## Safety Recall: Automatic Transmission 2nd Gear Inspection

(Supersedes 04-021, *Safety Recall: Automatic Transmission Second Gear Inspection*, dated November 16, 2004)

**A/T BEFORE INSTALLATION OF  
A/T OIL JET KIT**

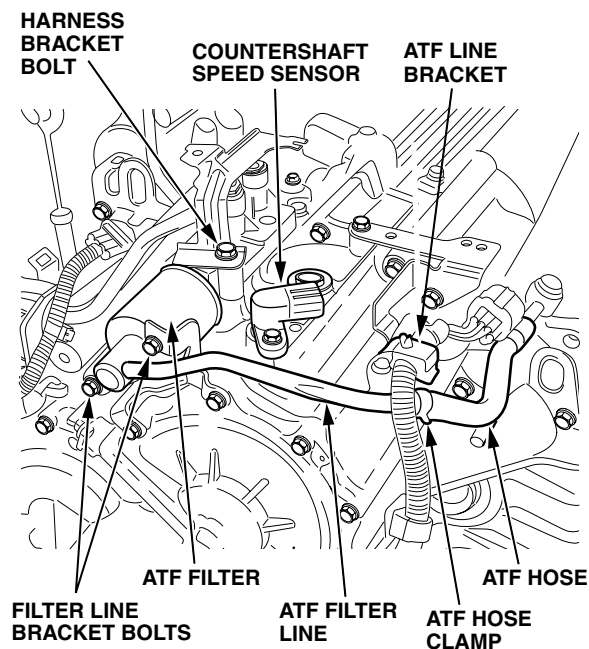
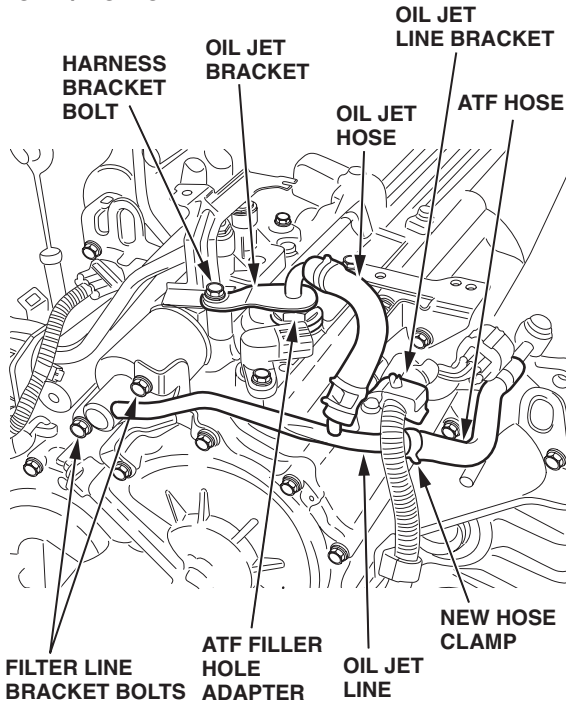
- Detach the wire harness from the ATF filter line bracket.
- Remove the ATF filter line bracket bolts, then remove and discard the ATF filter line.
- Assemble the A/T Oil Jet Kit outside the vehicle, but *do not attach the oil jet to the oil jet hose yet.*

10. Install the oil jet line onto the ATF hose with a new hose clamp.

**A/T AFTER INSTALLATION  
OF A/T OIL JET KIT**

11. Install the other end of the oil jet line onto the ATF filter. Torque the ATF filter line bracket bolts to **12 N.m (8.7 lb-ft)**.
